NAVIGATION - STALL WARNING HORN REPLACEMENT

The original stall warning horn is no longer available. If the stall warning horn needs to be replaced, a new stall warning horn is available and will require an additional bracket for installation.

MEB-34-07
Page 1 of 29

Figure 7. Group A Configuration 3 (Sheet 1)

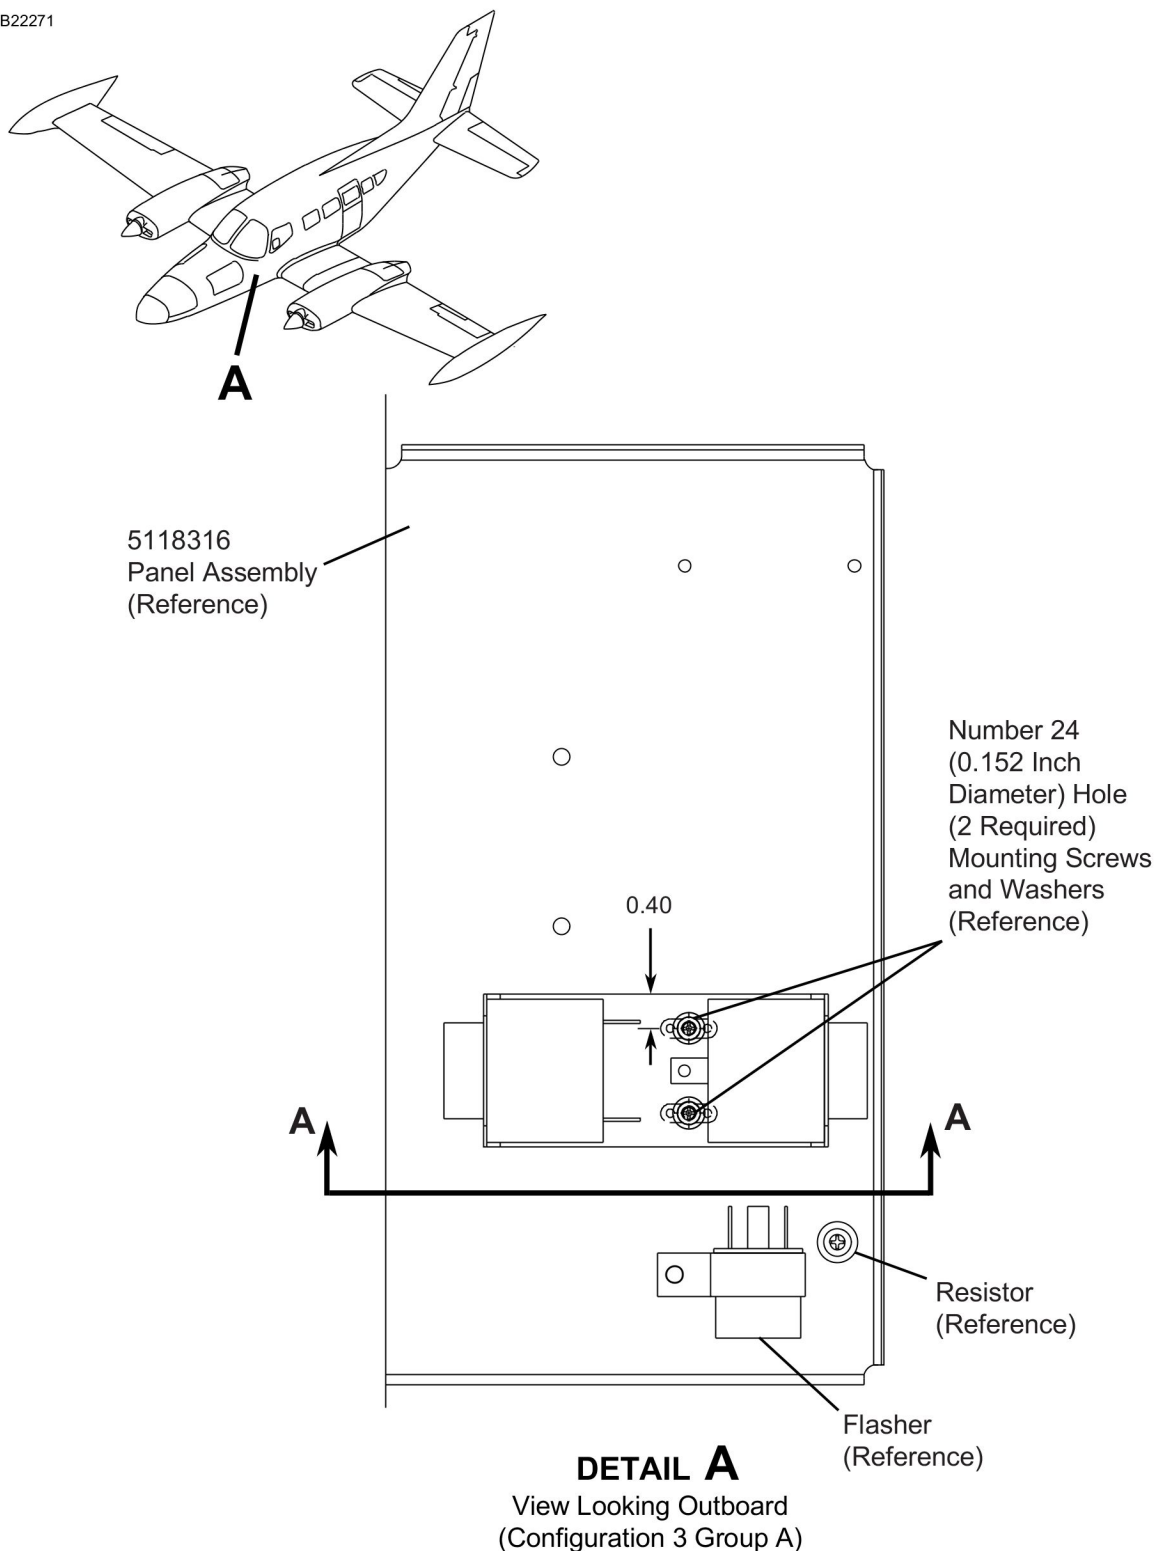
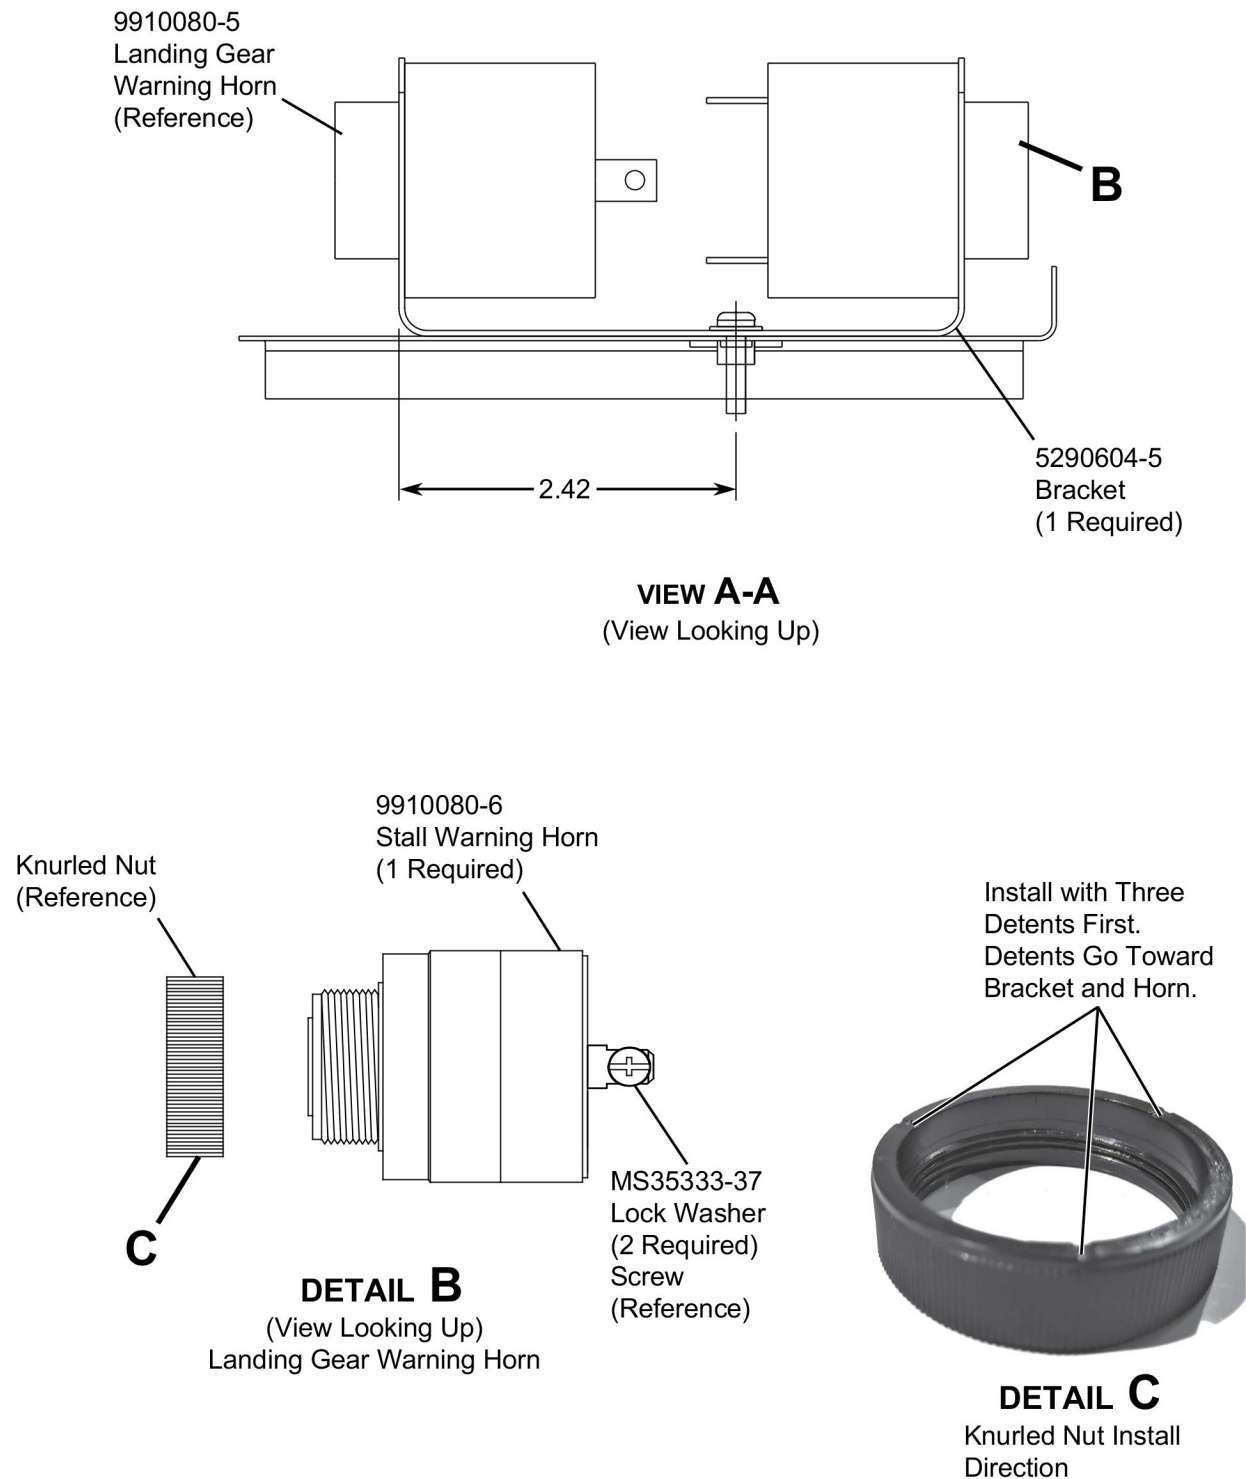
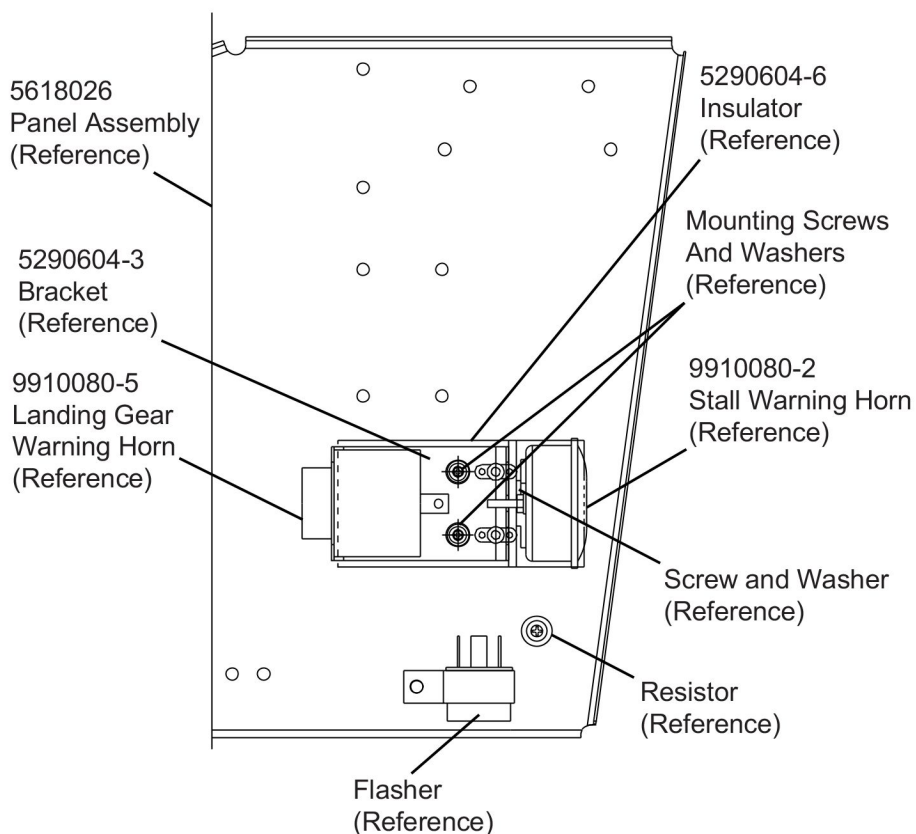
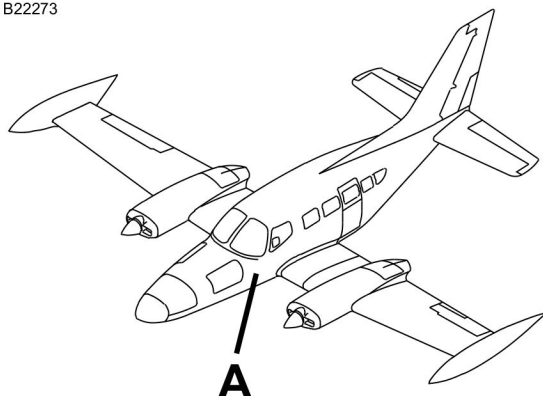
- 24. (Refer to Figure 7, Sheet 1 and 2.) Install the 9910080-6 Stall Warning Horn as follows:
 - A. Match drill the two Number 24 (0.152 inch diameter) holes of the 5118316 Panel Assembly to the 5290604-5 Bracket.
 - (1) Deburr the drilled holes from the 5290604-5 Bracket.
 - (2) Apply Color Chemical Film Treatment to all bare metal.
 - B. Install the 5290604-5 Bracket with the two kept mounting screws and the two kept washers into the 5118316 Panel Assembly.
 - C. Install the 9910080-6 Stall Warning Horn into the 5290604-5 Bracket.

- D. Install the knurled nut onto the 9910080-6 Stall Warning Horn.

- E. Install the labeled electrical wiring, screws, and the two MS35333-37 Lock Washers into the 9910080-6 Stall Warning Horn.

25. Install the kept 9910080-5 Landing Gear Warning Horn into the 5290604-5 Bracket.

Figure 8. Group B Before Configuration 3 Modification (Sheet 1)

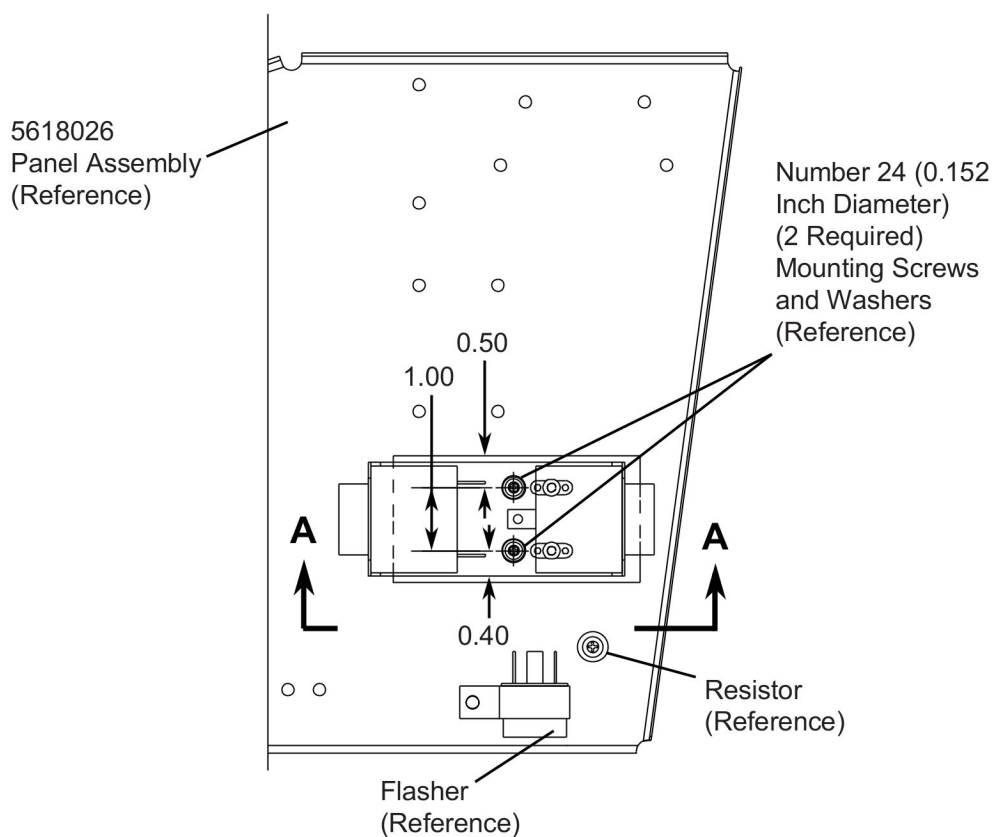
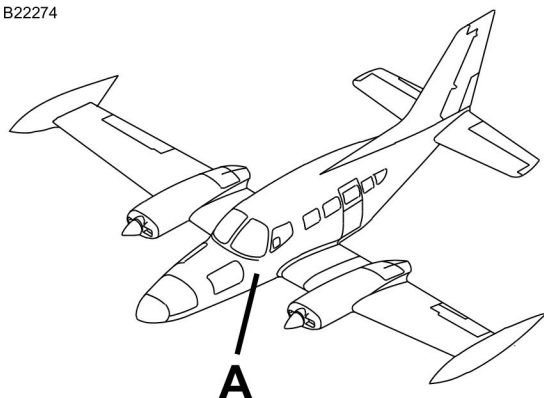
29. (Refer to Figure 8, Sheet 1.) Remove the 5290604-3 Bracket as follows:

- A. Remove and discard the screw and lock washer from the 9910080-2 Stall Warning Horn.
- B. Disconnect and label the electrical wiring from the 9910080-2 Stall Warning Horn.
- C. Discard all electrical hardware from the 9910080-2 Stall Warning Horn.
- D. Discard the 9910080-2 Stall Warning Horn.
- E. Remove and keep the 9910080-5 Landing Gear Warning Horn.

- F. Remove and keep the two mounting screws and the two washers from the 5290604-3 Bracket.
- G. Remove and keep the 5290604-6 Insulator.

- H. Discard the 5290604-3 Bracket.

Figure 9. Group B Configuration 3 (Sheet 1)

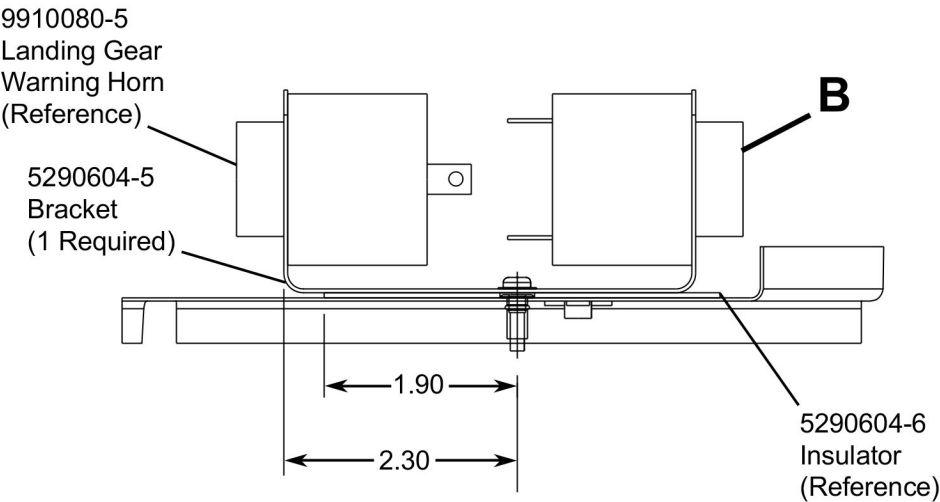
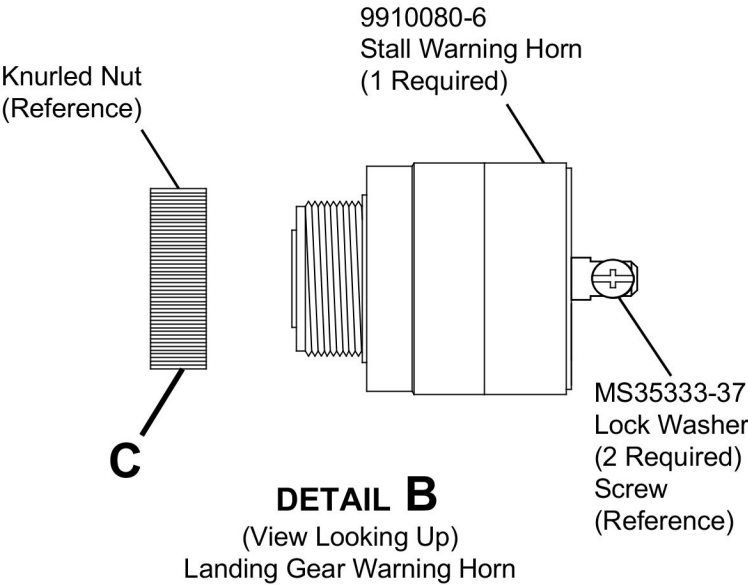
31. (Refer to Figure 9, Sheet 1 and 2.) Install the 9910080-6 Stall Warning Horn as follows:
- A. Match drill the two Number 24 (0.152 inch diameter) holes of the 5618026 Panel Assembly to the 5290604-5 Bracket.
 - (1) Deburr the drilled holes from the 5290604-5 Bracket.
 - (2) Apply Color Chemical Film Treatment to all bare metal.
 - B. Install the 5290604-5 Bracket and the kept 5290604-6 Insulator into the rivnuts of the 5118316 Panel Assembly with the two kept mounting screws and the two kept washers.
 - C. Install the 9910080-6 Stall Warning Horn into the 5290604-5 Bracket.
 - D. Install the knurled nut onto the 9910080-6 Stall Warning Horn.

NOTE: The plastic knurled nut must be installed with the three indents toward the bracket and horn assembly. On the internal circumference, the smooth side without threads is installed first, towards the bracket and horn. This technique of installation will make sure the nut fully seats against the bracket and not bottom-out on the threads. If not installed correctly the knurled nut will bottom-out on the threads and the horn assembly will not be fully tightened in the bracket.
 - E. Install the labeled electrical wiring, screws, and the two MS35333-37 Lock Washers into the 9910080-6 Stall Warning Horn.

NOTE: The screws are supplied with the 9910080-6 Stall Warning Horn.
32. Install the kept 9910080-5 Landing Gear Warning Horn into the 5290604-5 Bracket.
33. Do the 9910080-6 Stall Warning Horn operational check as follows:
- A. Remove the maintenance warning tags and connect the airplane battery.
 - B. Put the avionics power switch to the ON position.
 - C. On the left wing tip, activate the stall vane by pushing the tab up.
